Minor Amendment to Site Plan

Meeting/Hearing Date: N/A	Fee Total: \$50
Staff Signature: Vanessa A Segura	Date: 8/4/2020 Project # PR-2020-004213

**RE: ADMINISTRATIVE AMENDMENT REQUEST  
PROJECT #: PR 2020-004213  
PARADISE CHARTER SCHOOL**

**RE: PRIMROSE SCHOOL  
ADMINISTRATIVE MINOR AMENDMENT TO SITE PLAN  
4550 PARADISE BLVD. NW ALBUQUERQUE, NM 87114  
ZONE ATLAS PAGE C-13-Z**

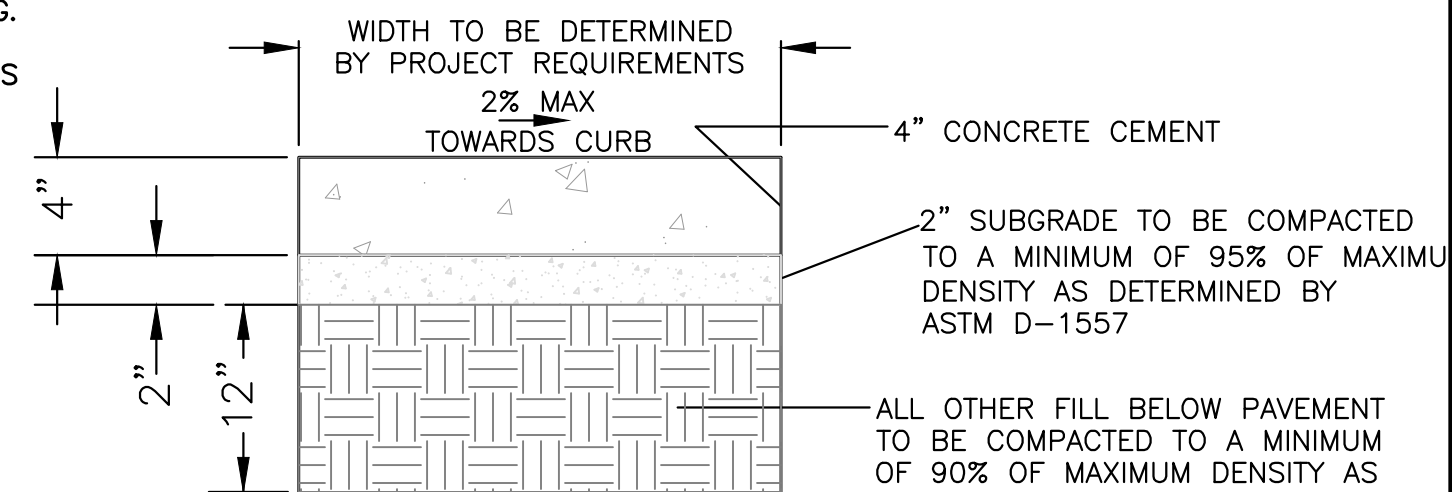
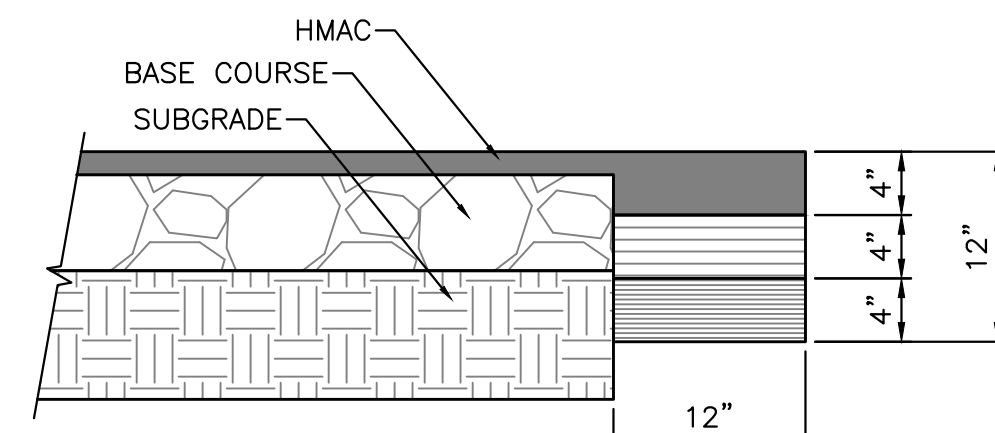
1. List number of students for charter school. Show traffic circulation for school drop-offs and queuing patterns. This is for safety purposes and to keep cars from backing into public right-of-way as well as to provide a smooth circulation pattern for a high queue of vehicles.

3. Show 6-foot pedestrian connection to the proposed sidewalk along Paradise Boulevard.  
(There is a gap.)  
**The sidewalk is now shown to connect to the sidewalk along Paradise Boulevard.**

8. If the lot line runs down the middle of the driving aisle, shared access/parking is needed. Provide copy of this if one has been obtained.

**The maximum capacity of students is 190 and we now list that in the Site Data table. The school serves infants and toddlers up to age 4. Kids will be dropped off between 6:30 am and 8:00 am and picked up between 5:00pm and 6:30pm. The school will have two 14 passenger buses that is may use for pickups from elementary schools. Vehicle will be allowed to use the gravel access road to the east entrance. We do not anticipate a large traffic que like for a typical Charter School.**

**That is the proposed lot line that is not platted. When the land owner submits for Phase II construction a plat will be filed with the shared easements. There is a note on this Site Plan stating those easements will be filed at the time of Plat.**

**BIKE RACK DETAIL**  
SCALE: 1/2"=1'

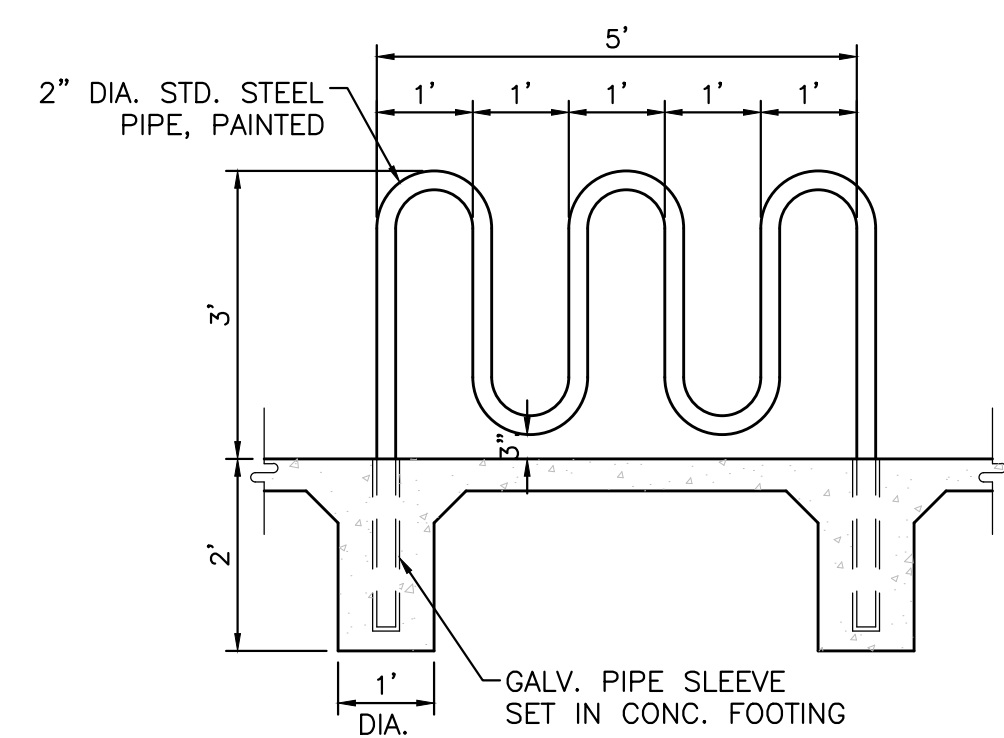
4. Provide details referenced in keyed notes, and include bike rack detail.  
**The sheet with the details is now included with this submittal.**
5. A 5-foot keyway is required on the east edge of the parking lot for vehicles backing out if the extra parking lot is going to be eliminated
